Public Consultation Submission **Wyattville Road (Phase 2)**

Dún Laoghaire-Rathdown published a [Public Consultation report](#) and [Layout Plans](#) for Wyattville Road cycling in July 2020. This follows the completion of the Phase 1 scheme in 2017. This is a non statutory consultation.

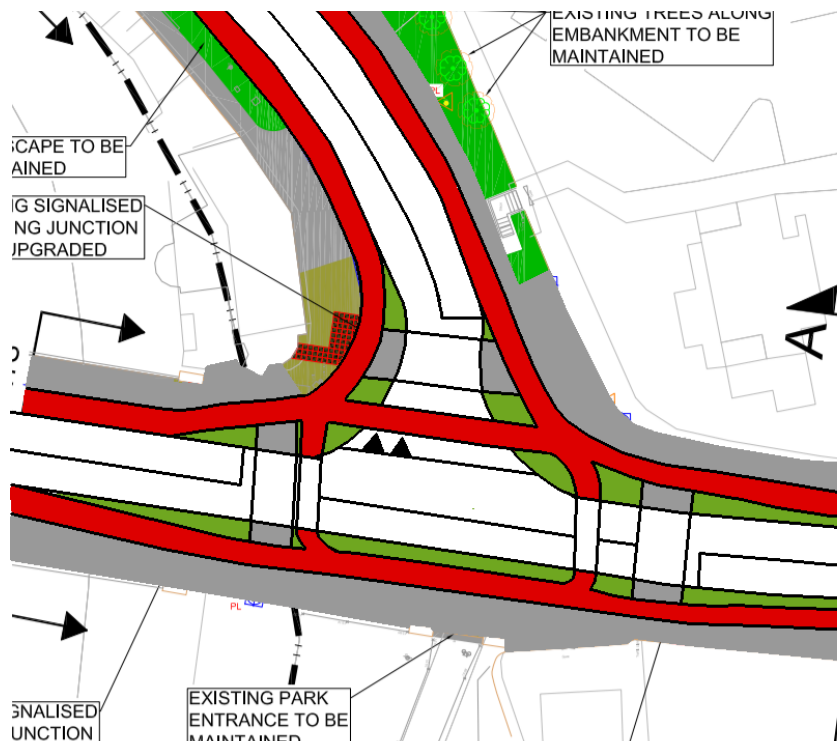
- We welcome the addition of the permeability link to Oakton Park. We request that this link be protected from vehicle access with a single bollard in order to facilitate all users including mobility scooters, cargo bikes and double buggies. The barriers typically installed by the Council at laneways and permeability links may not be compliant with the Disability Act.
- The junction design at Churchview Road does not enable or encourage cycling for all ages and abilities. We strongly request that the designers are instructed to design a protected junction as has been proposed in other cycle schemes recently. E.g. Bus Connects. An example of a 3-way protected junction below.

Layout sheet 1

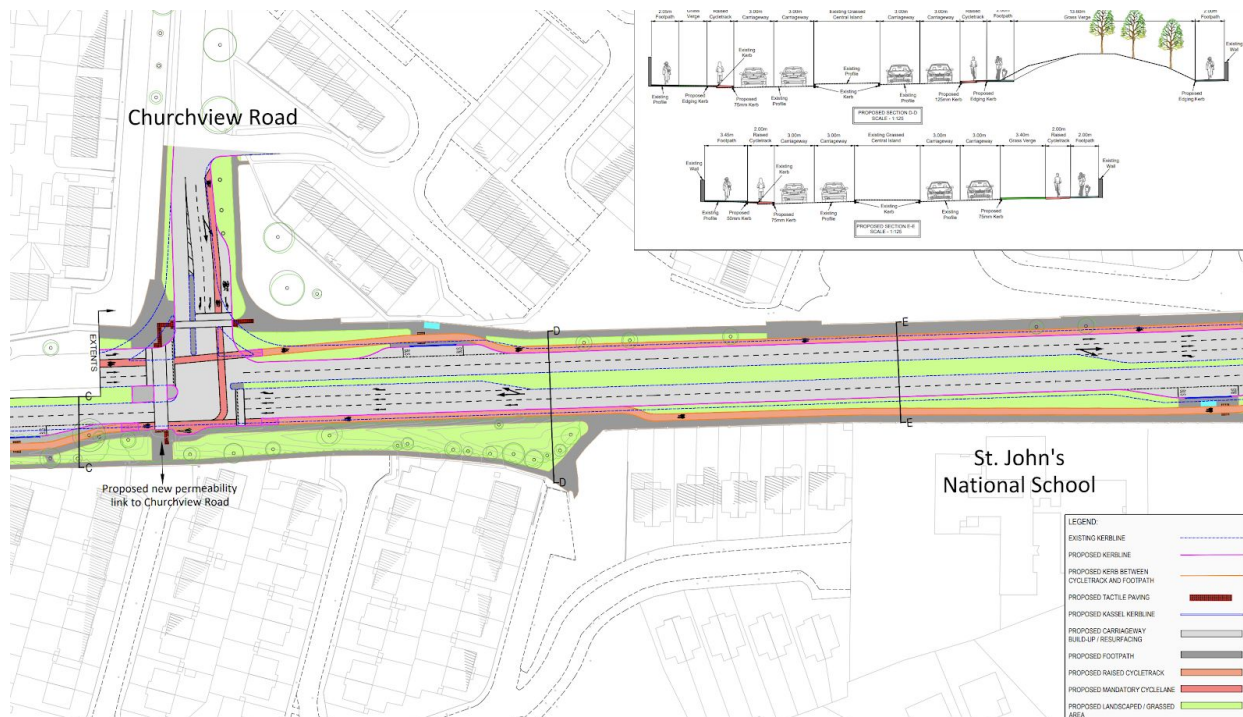
- At a very minimum, cycle lanes that split between 2 traffic lanes are not safe. Rather than hoping for plastic traffic wands to retro-fit the junction later, Dublin Cycling Campaign would like to see full segregation through the junction, using cyclist traffic lights if necessary. Cyclists should be kept on the left of all traffic lanes, not lane splitting. The (staged) image below illustrates the design planned for this scheme's junctions and how it will not encourage people of all ages and abilities to cycle.

- The designs currently have 3 general traffic lanes coming from Churchview Road onto Wyatville Road. This has no effect on increased junction capacity as just 50 metres back on Churchview Road, the road has just one lane going towards the junction. The Council should ask the designers to reduce this to one traffic lane and one protected cycle track. This would have benefits of making the crossing shorter for pedestrians and increase safety for all road users on approach to the junction by minimising lane-changing. Reducing lanes would mean removing the traffic island too, further decreasing crossing distance for pedestrians.

Layout sheet 2

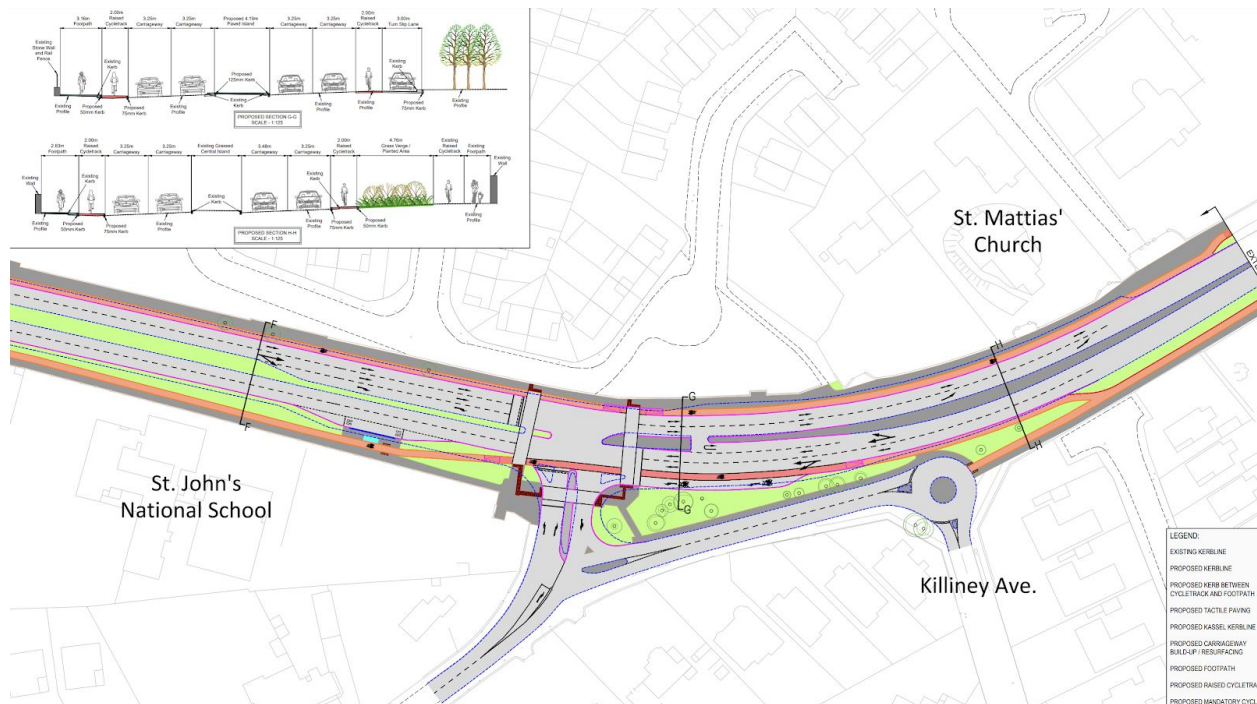
- There should be clearer cycling links to/from St John's National School. The route could go through the gap in the wall at Oakton Park to access Oakton Green where the entrance to St John's is.
- A buffer (not just a small kerb) between the cycle lane and traffic lanes on both sides of the road would greatly increase Comfort for people cycling. Space could be taken from the overly wide median.
- The island bus stop on the western side of the road is designed differently to the others. The cycle track should go behind the bus stop so as not to conflict with passengers as they board/alight/signal/wait for the bus.
- There is no permeability link on the western side of the road between the Churchview Road junction and Denville Court. A distance of 450 metres. The ideal place for such a new link would be directly opposite the Church Road

junction, for the same reasons as the Oakton Park link is being proposed (i.e. direct access to the crossing at the Church Road junction).
